**Edwin I. Hatch Nuclear Plant
Request to Implement an Alternative Source Term**

AST Safety Assessment

Description and Justification for Proposed Change

Figure 1. MSIV Alternate Leakage Treatment Pathways

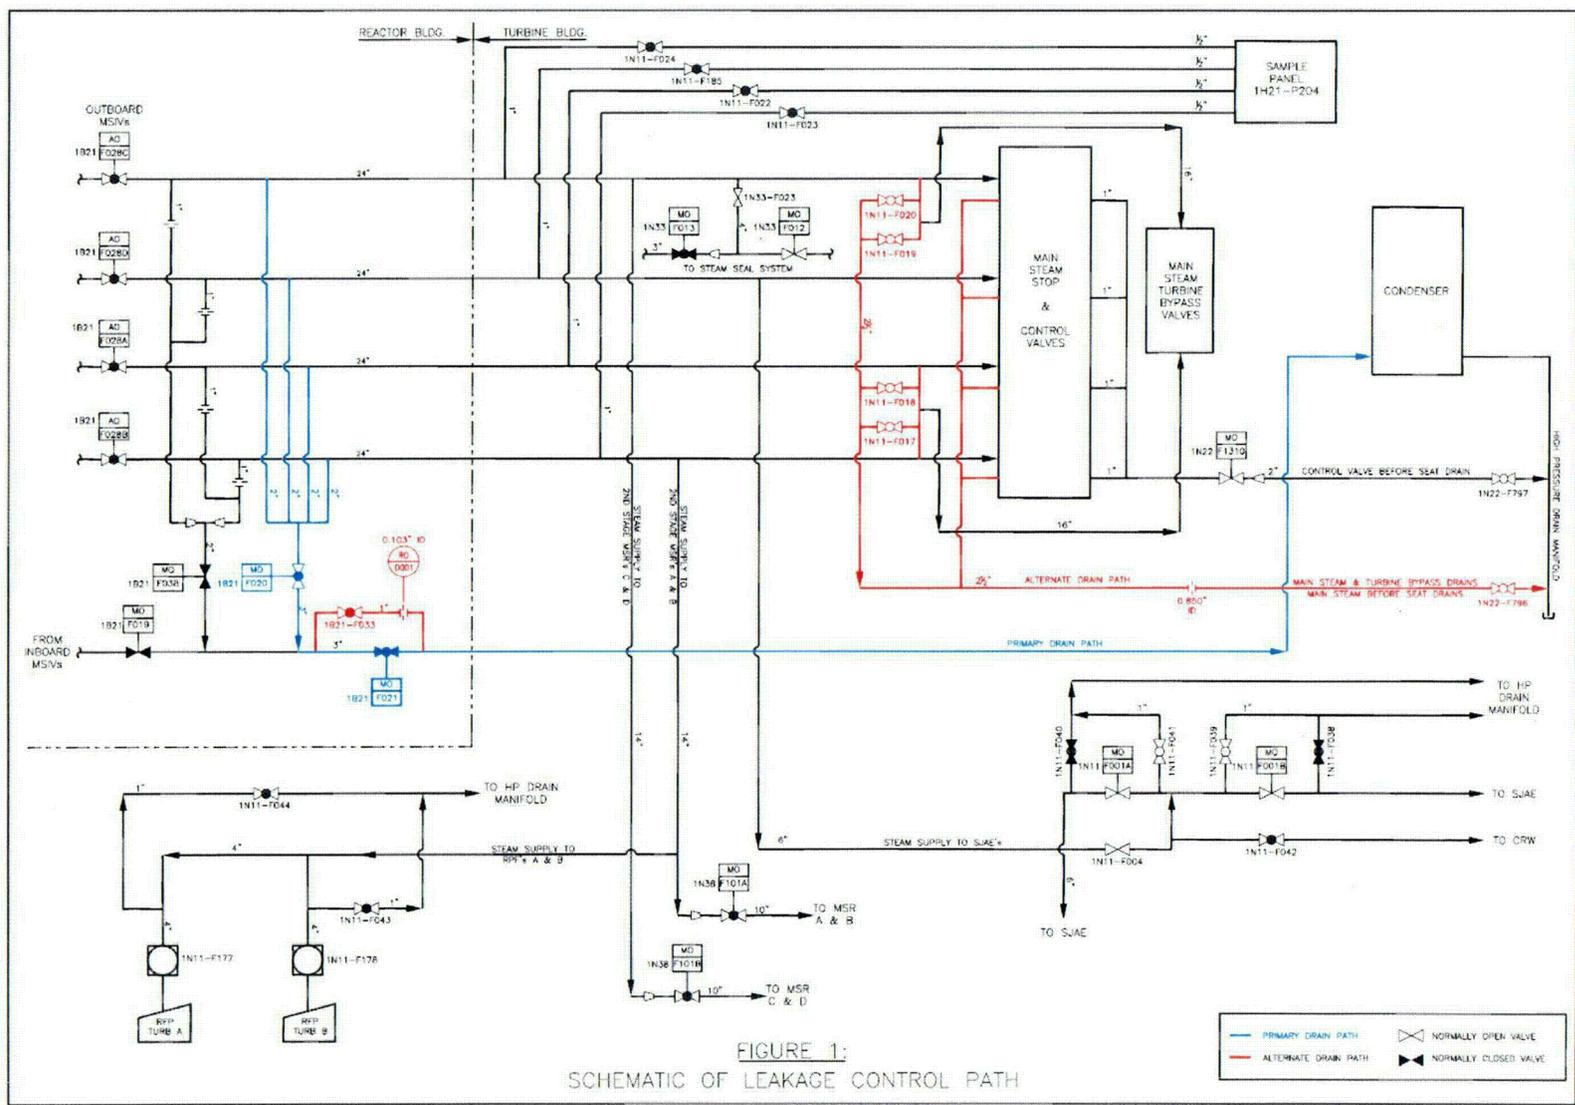
The HNP ALT pathway for Unit 1 utilizes the large volume of the MSLs and the main condenser to provide holdup and plate-out of fission products that may leak through the closed MSIVs. The primary components of the ALT pathway are the main condenser, the MSLs from the MSIVs to the turbine stop and bypass valves, and the drain piping which originates downstream of the outboard MSIVs and terminates at the main condenser. The condenser forms the ultimate boundary of the ALT pathway. Existing valves upstream of the condenser are used to establish the flow path and isolate the boundaries of the path and to limit the extent of seismic verification walkdown. The model for evaluating reduction of MSIV leakage is provided in Reference 3. Figure 1 shows a schematic of the primary and secondary ALT pathways.

The ALT pathway must be capable of performing its post-LOCA function during and following a DBE, assuming offsite power is not available. The valves required to be opened in order to establish the path to the condenser, and boundary valves required to be closed to establish the path boundary, are included in the plant's Inservice Inspection Program. The only active valve required to open to establish the ALT pathway, MOV 1B21-F021, is powered from Class 1E power sources and can be opened from the MCR in the event of LOSP.
